VARIANCE REQUEST ANALYSIS TPV 18-033

Project:	River Rock Ranch MDP
Address:	Boerne Stage Road & River Ranch
A/P #/PPR #/Plat#:	AP# 1803747
VR Submittal Date:	September 20th, 2018
VR Submitted by:	Mr. Mark Kastner, P.E., of Coursen-Koehler Engineering on behalf of Jeff Hutzler of Green Land Ventures
Issue:	Below 100% heritage tree preservation within Environmentally Sensitive Area (2015 Ordinance)
Code Sections:	Unified Development Code (UDC), Section 35-523 (h)
By:	Herminio Griego, Assistant City Arborist

RIVER ROCK RANCH VARIANCE EXHIBITS

EXHIBIT 1

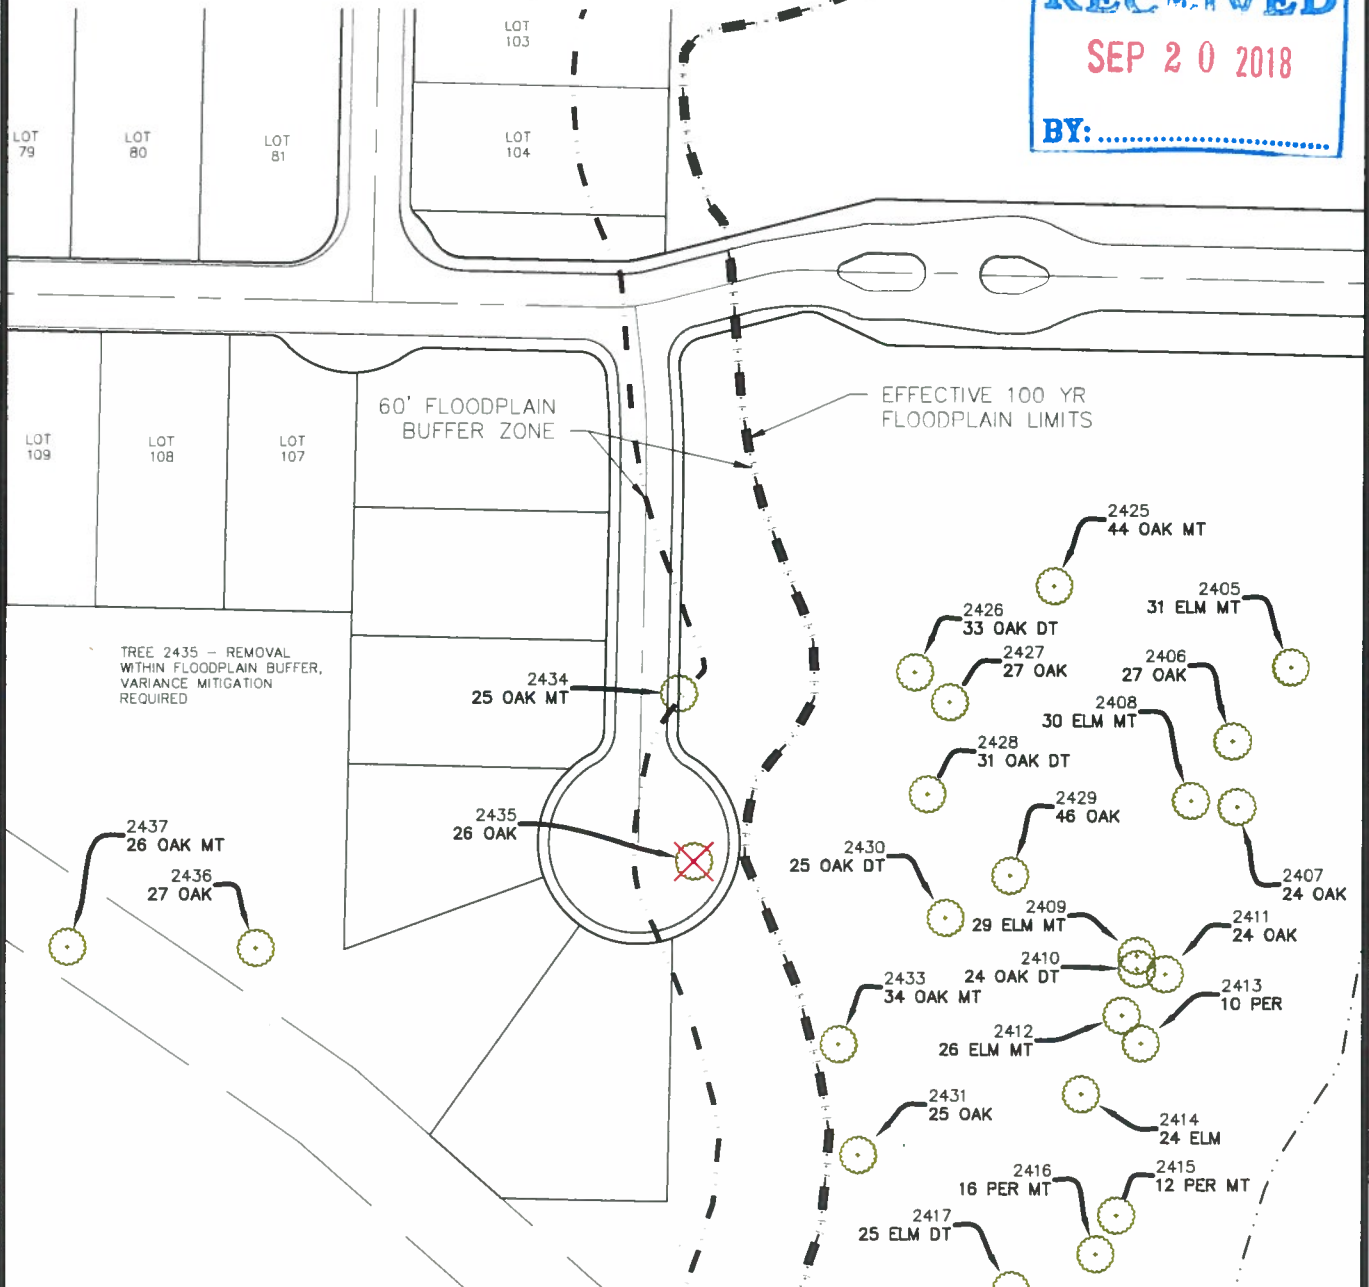
1. *Existing site conditions* - Due to existing site conditions, design and layout constraints, the project is unable to preserve the minimum 100% of heritage trees within the Environmentally Sensitive Area (ESA). The land plan for the additional units of River Rock Ranch includes a private street that partially encroaches into the 60' floodplain buffer. The project contains a total of three heritage oak trees located within the 60' floodplain buffer. Of the three existing heritage trees, one 26 inch Live Oak will have to be removed for the construction of a new road. The other two heritage trees will be preserved. The proposed ROW cannot be revised or relocated to avoid the one 26 inch heritage oak tree.

Section 35-523(h) states that heritage trees located in the 100-year floodplain and ESAs shall be preserved at one hundred percent. The land plan for the additional units of River Rock Ranch includes a private street that partially encroaches into the 60' floodplain buffer. A 26" oak tree, classified as a heritage tree, is located within a portion of the right of way (ROW), and is also inside the floodplain buffer. The developer intends to mitigate the removal of this tree by planting additional trees, around a detention pond and water quality pond, which are part of this additional development, as well as along the private streets in

Per said section, mitigation of this tree is prohibited unless a variance is granted by the Planning Commission. A variance to UDC 35-523(h) is requested to allow the developer to remove the single heritage tree located within the private ROW and floodplain buffer. Adherence to the standard requirement for this specific instance will create undue hardship for the developer with the following characteristics:

Due to constraints of the 100-year floodplain to the south of the proposed ROW, and existing residential lots and infrastructure to the north, the proposed ROW cannot be revised or relocated to avoid the tree in question. Granting this variance will not be contrary to the spirit and intent of the UDC because, outside ESAs and floodplains, heritage trees that fall within proposed ROW's are exempt from mitigation requirements when removed, and the developer will mitigate the tree's removal at a 4:1 ratio within the development, which is above and beyond the required 3:1 ratio specified in the UDC. The developer has explored all practicable measures to minimize any adverse impacts to public health, safety, and public welfare, and has committed to mitigating the single tree to potentially improve public welfare, by providing additional trees in areas that are more visible and visited by the general public. Granting of this variance will provide more benefit to the public interest than requiring the tree in question to remain. The unit associated with this variance will not be feasible due to land restraints if the tree is not removed, as there is not another way to extend the ROW around the tree to service the proposed lots. Additionally, removal of the existing tree will be mitigated with 53 additional trees.

DSD staff supports the applicant's request to fall below 100% of heritage tree preservation requirements in the Environmentally Sensitive Area (ESA) based on the conditions of the site, design constraints, and exceeding mitigation and canopy requirements. The proposed Variance Request meets the intent and spirit of the Tree Ordinance therefore, staff recommends approval.

RECOMMENDATION: Approval
